Subject: Kilarc-Cow Creek Project (FERC Project No. 606)

Response to FERC Additional Information Request in Letter dated September 3, 2009

Response to AIR

COV CREEK STREAM SYSTEM
 EXCEPTING
 CLOVER CREEK, OAK RUN CREEK AND NORTH COV CREEK

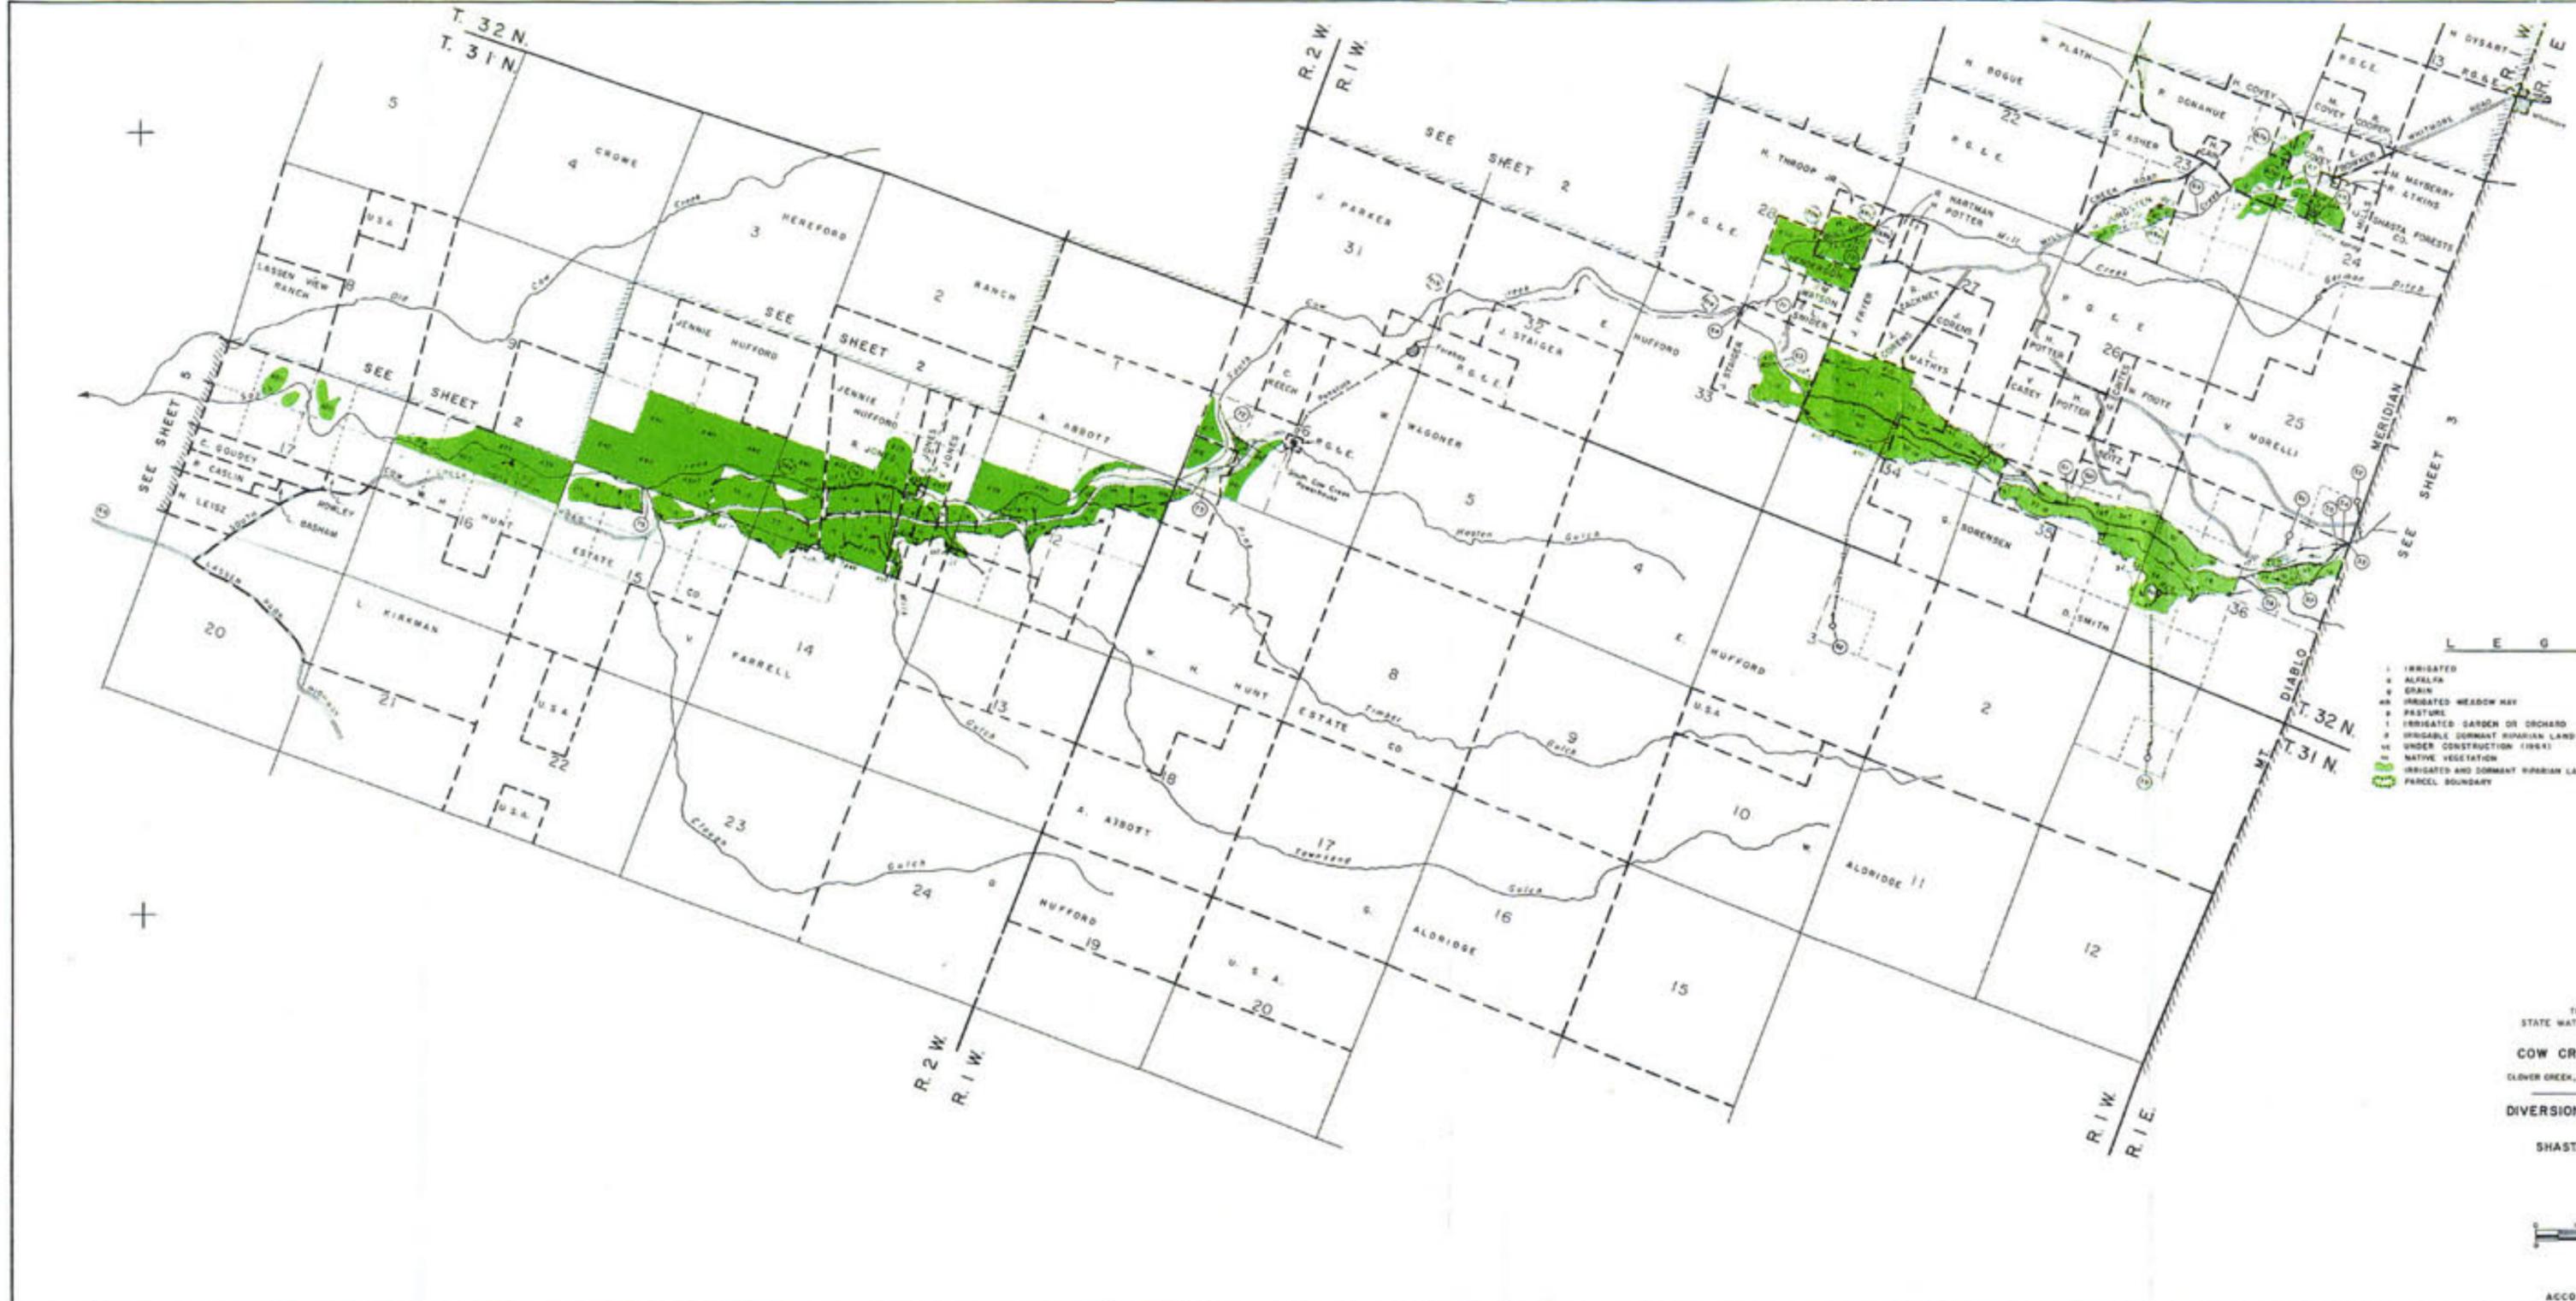
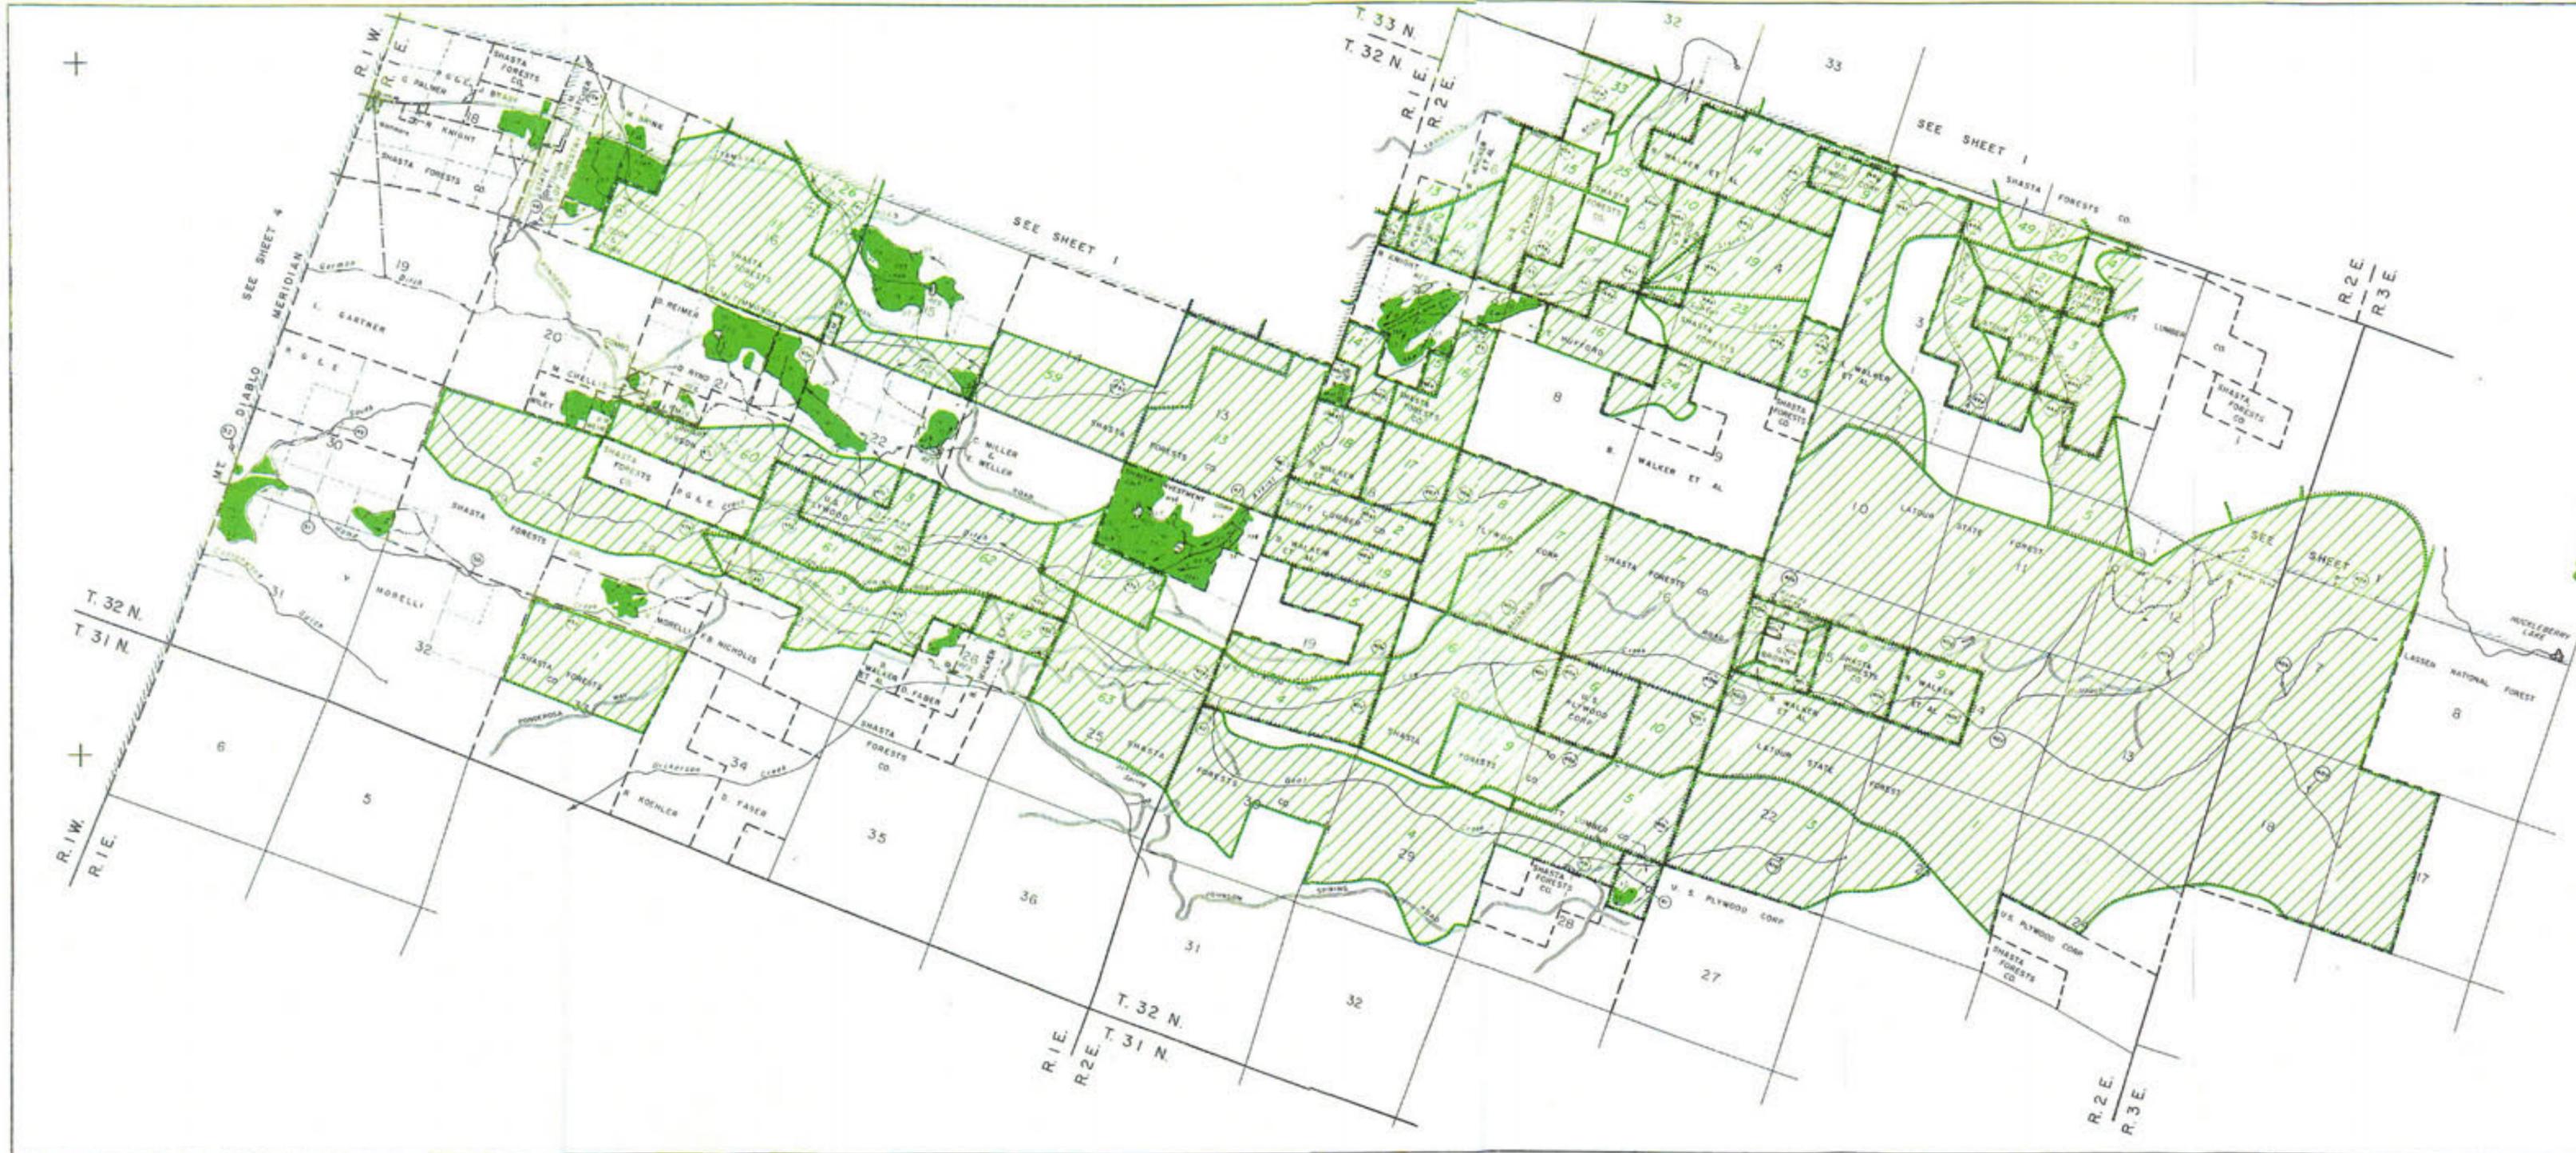
Water Resources Item 3: *Please provide a map of the Old Cow Creek and South Cow Creek basins indicating the location of other diversions and licensed or exempt hydro projects above and below the Cow Creek and Kilarc developments.*

RESPONSE – Water Resources Item 3: Attachment M contains the diversion maps from the 1969 Adjudication of Old Cow Creek, South Cow Creek, and Lower Cow Creek. See "In the Matter of the Determination of the Rights of the Various Claimants to the Water of Cow Creek Stream System Excepting Clover Creek, Oak Run Creek and North Cow Creek in Shasta County, California", Case No. 38577 (Shasta Cty. Sup. Ct., August 25, 1969). The Adjudication remains the operative document codifying water rights for the Cow Creek system.
